ADDENDUM NO. 1

HELENA FIRE STATION #3

PROJECT: Helena Fire Station #3
Helena, Montana

ARCHITECT: DOWLING Architects
734 North Last Chance Gulch
Helena, MT 59601
406-457-5470

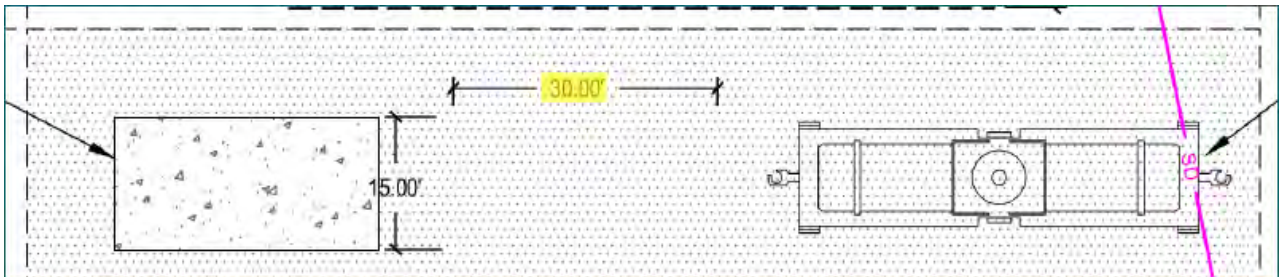
2. **Question:** Please provide a thickness for the commercial rated compacted road base shown on C3-1.

Answer: Geotechnical recommendation as follows:

Provide min. 12" compacted base course

1. Base course shall meet Montana Public Works 1.5" minus crushed base course (same as specified in geo report).

2. Place base course in 8-inch (max) loose lift thickness and compact each lift to a minimum standard relative compaction of 95%.
3. Use additional base course, if needed, to meet design grade based on subgrade preparation (removal of topsoil/fill/debris).

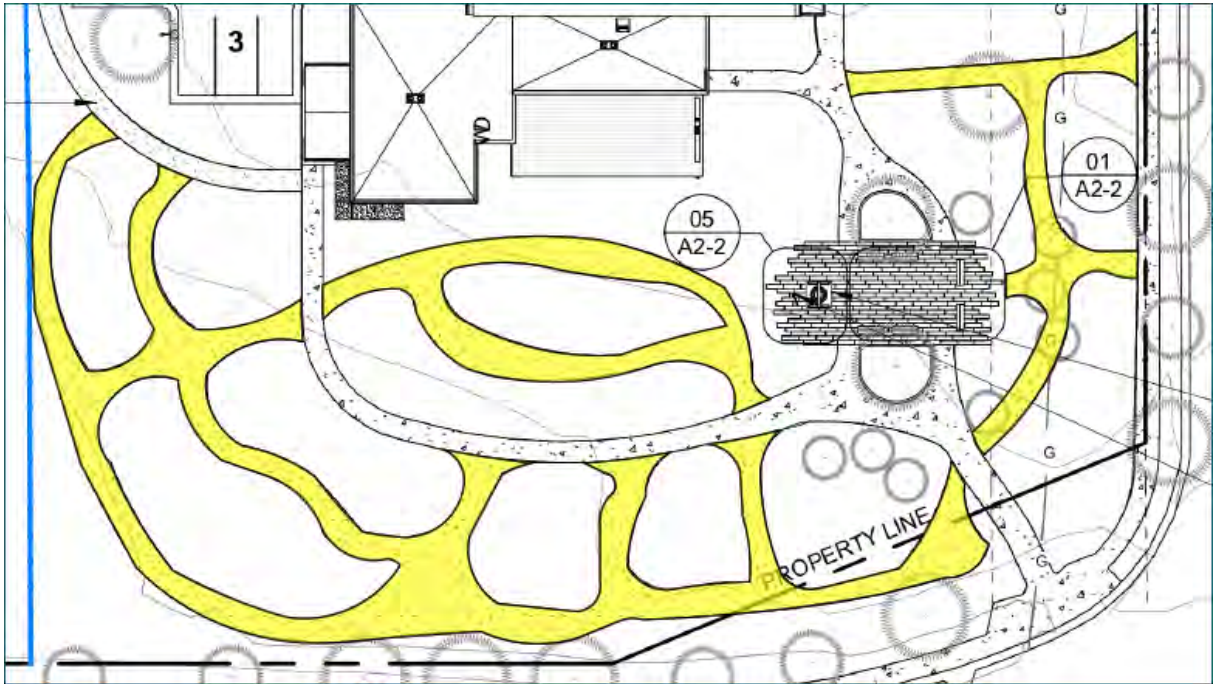
10. **Question:** Please reference the green highlighted area in the screenshot from L0.0 below. This area is defined as a Firewise demonstration garden where per Keynote 2 on L0.0, planting is by others. Please clarify if the trees shown in this area are included in this contract or are in fact, by others under a different contract.

Answer: All planting shown on L2.1, including trees and shrubs depicted in the firewise area, are part of this contract.

E3

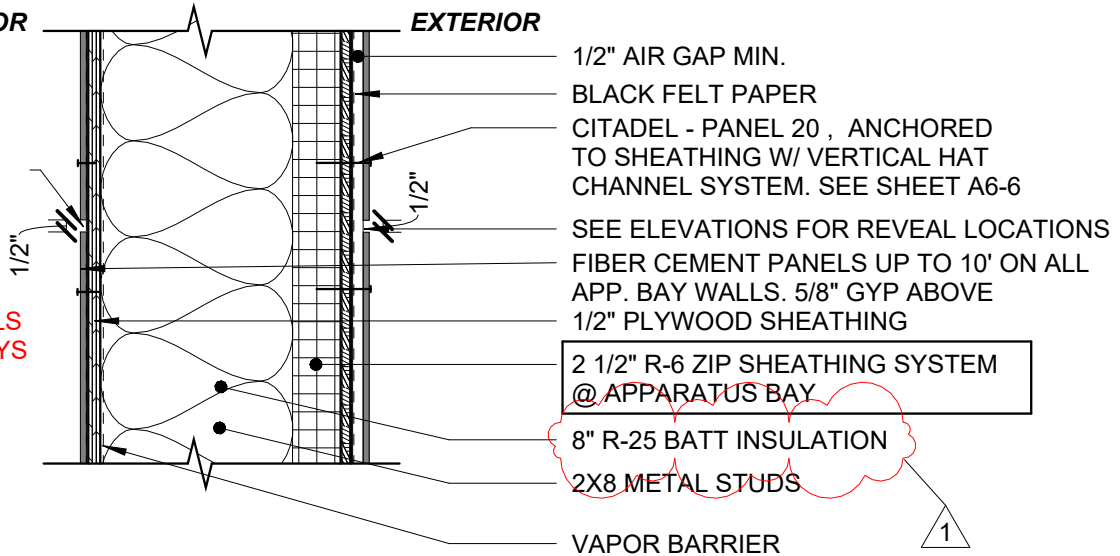
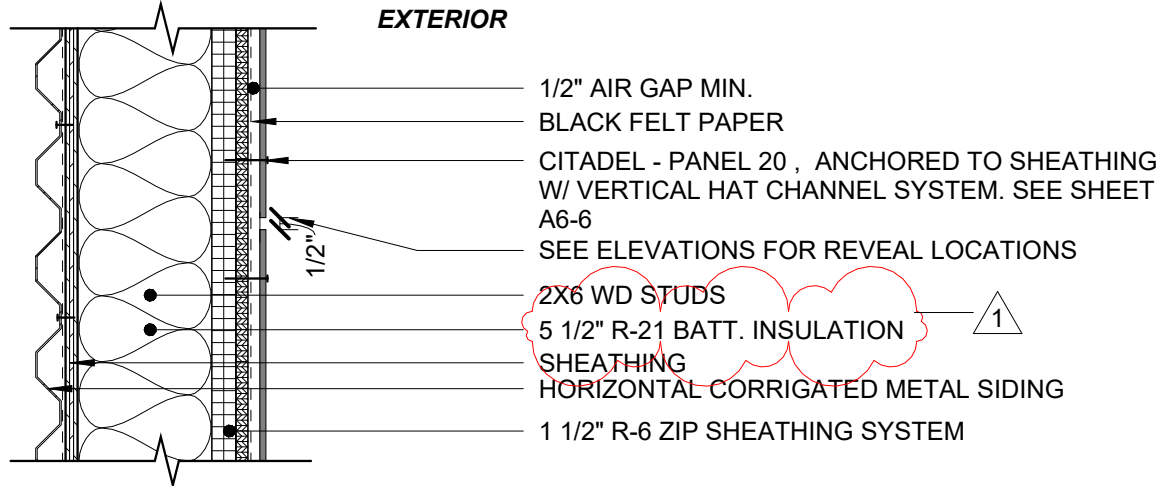
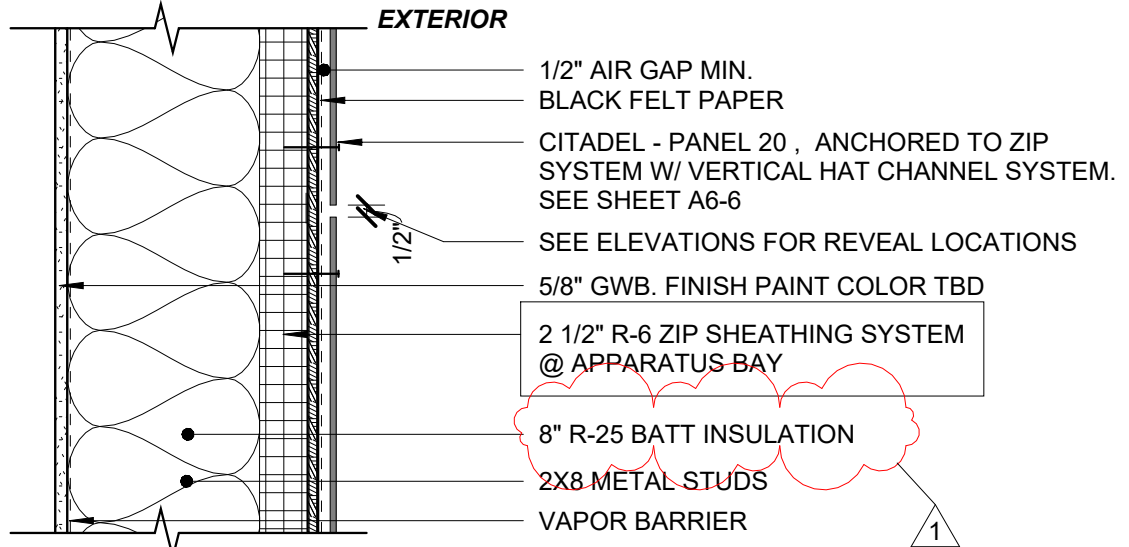
- **Sheet A1-2 (Wall Assemblies E3, E4, & E5)** Walls E3, E4, E5 adjusted notes regarding batt insulation, see attached drawing **ATT1**.
- **Sheet A1-3 Door & Window Schedule in its entirety**, Added note for window type F & G requiring hollow metal frame due to fire rated assembly. Added Door Frame Type 4, and Door Type H. Clarified schedule items for door 101A & 102

SEE INT.
ELEVATIONS FOR
REVEAL
LOCATIONS. SHEAT
HING TO BE
PAINTED BLACK AT
ALL REVEAL
LOCATIONS

1 ROOF PLAN REVISION
ATT-2 1/8" = 1'-0"

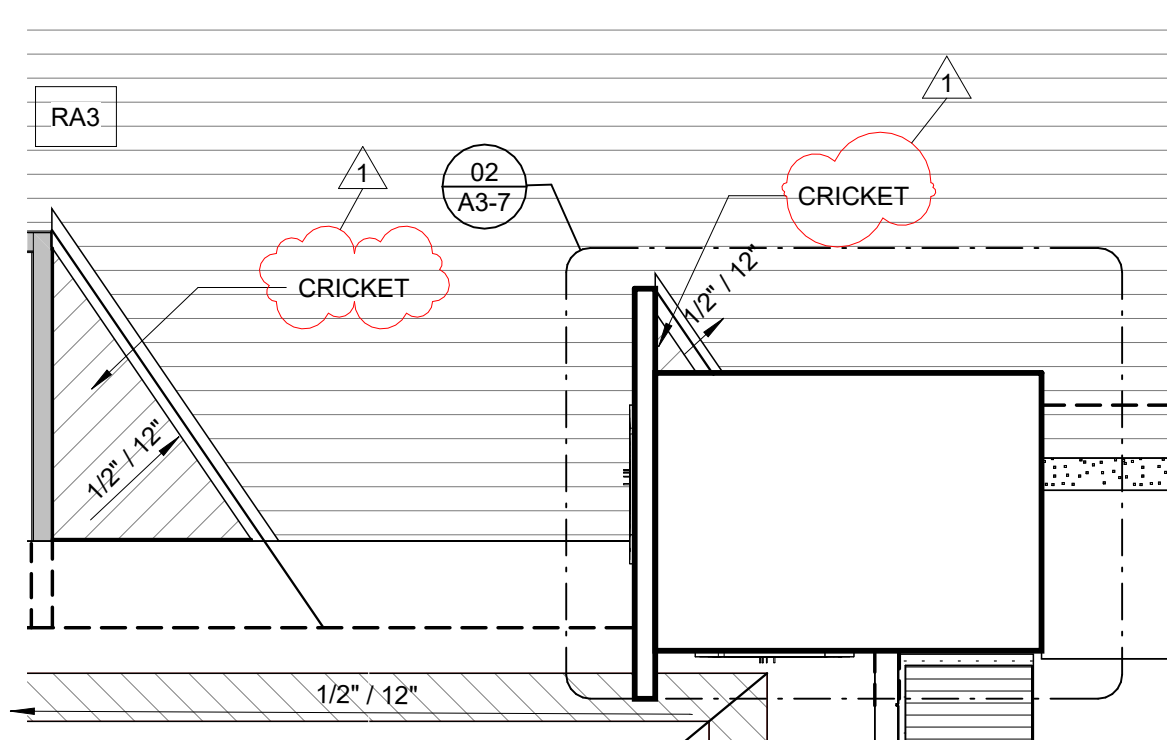
- **Sheet A3-7 Roof Plan**, note added to for the crickets shown on roof plan. Reference attached drawing **ATT2**
- **Sheet A7-3 Detail 01**, Added note/drawing for cabinetry casework to enclose safe haven baby box w/ electronic code lock. Cabinetry to match adjacent casework aesthetically and be enclosed on the sides, front, and top (top to provide air ventilation as drawn in ATT-4), but not the back. Cabinetry will need to leave toe kick open to allow airflow inside in the event of use. Reference attached drawing **ATT4**

SITE PLAN ADDENDUM

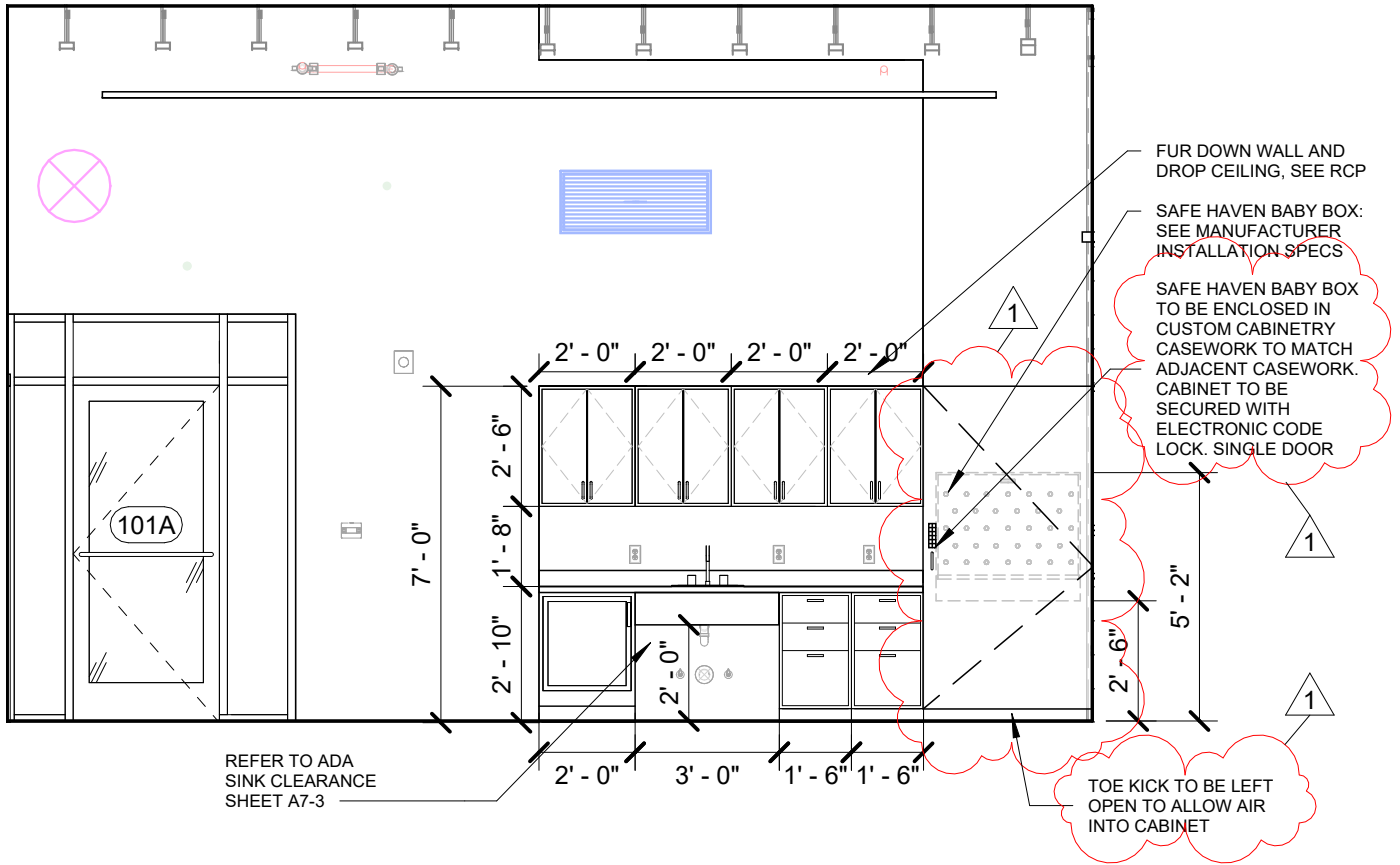
1. **Question:** C3-1 Calls for a "Future L Trench Prop (Bid Alternate)". Per the bid form and bid sheet, there do not appear to be any bid alternates on this project. Please confirm that there is no bid alternate for a future L trench prop.

3. **Question:** There is a 30' dimensions shown on sheet C3-1 between the concrete pad for dumpster prop and the future rail car prop, but the dimension does not appear to be measuring anything. If this dimension is relevant, please provide information on the plan sheet as to what it is for.

- **Sheet A2-1 Site Information**, removed notes regarding bid alternatives for L Trench Prop & Asphalt Flat Work. Reference attached drawing **ATT3**
- **Sheet A3-6 F.F. & E in its entirety**, refined for increased clarity, specifically in regards to what items are OFOI, OFCI, or CFCI

Answer: The "(Bid Alternate)" has been removed from C3-1 for the next addendum.

Answer : *These dimensions were intended to go to the adjacent concrete pad to the west - this has been revised in C3-1 for the next addendum.*

ENLARGED
SITE AND
UTILITY PLAN

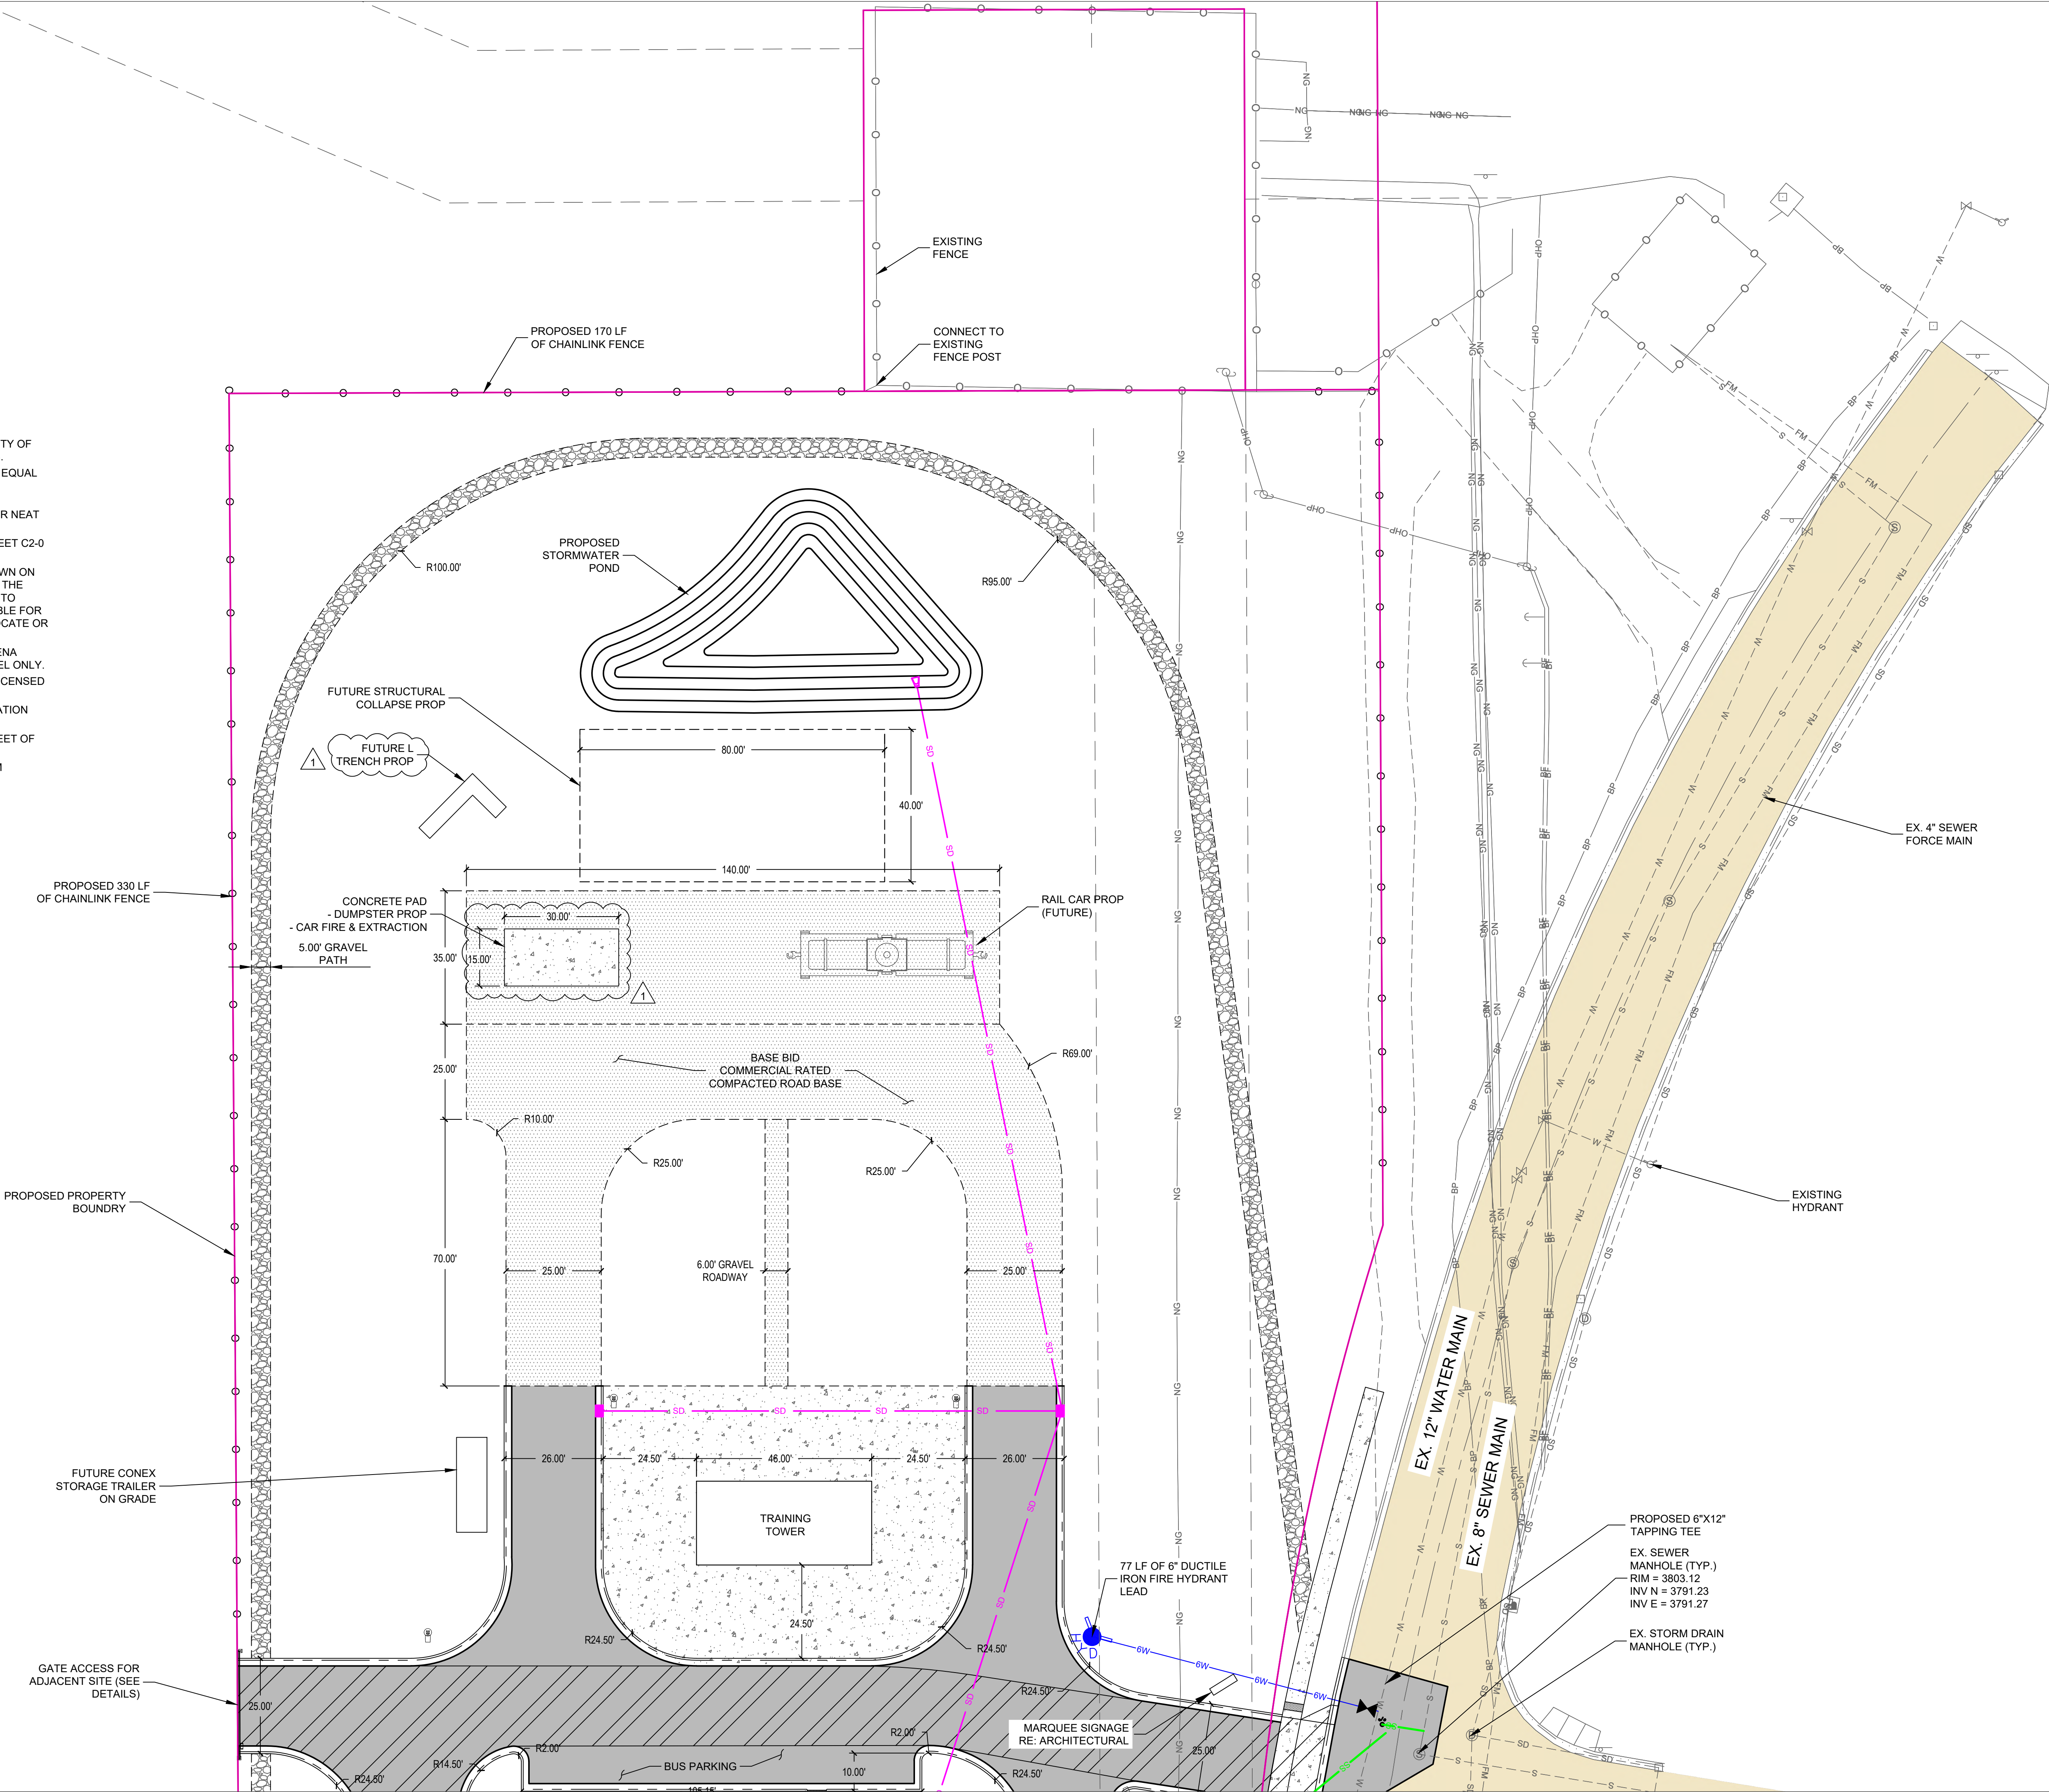
- **Sheet C3-1**, Bid Alternate removed from Future L Trench Prop, dimensioning concrete pad adjustment, clarification of landscape path being proposed granite, additional detail for gravel road base
- **Sheet C3-2**, Covered parking removed, added additional clean out notations
- **Sheet C4-1**, Added material types on the storm piping
- **Sheet C4-2**, Added material types on the storm piping, added new manhole per COH Stormwater Comments,

- *"The plans state there is to be a cleanout installed every 100 LF. However, there are not shown on the plans."*
 - **Cleanouts have been added at the appropriate locations**
